Project Address: 24 Phoebe Drive  
Neptune NJ 07753  
Municipality: Neptune Township  
Subject: Impervious Coverage Area; Driveway Extension

This report addresses issues relative to Zoning Permit Application that are noted in "Zoning Permit" document provided for reference. As requested, primary focus is on impervious coverage area.

Survey Of Property

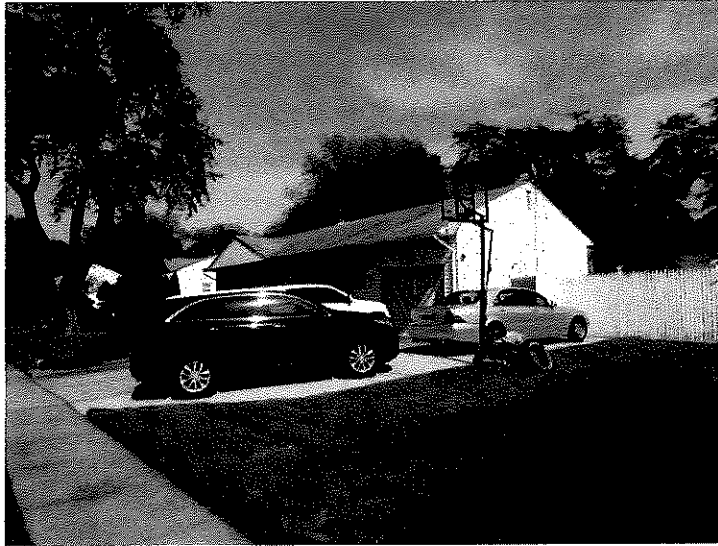
\*\*\* In-ground pool should not be included for impervious area since pool does not produce runoff of rain water. This is specified in Ordinance 15-09.

+++ Area of deck more than 12-inches above average grade does not have to be included per Ordinance 15-09.

Roof overhang along front of house is shown by dashed line. Roof overhang at back of house is not shown.
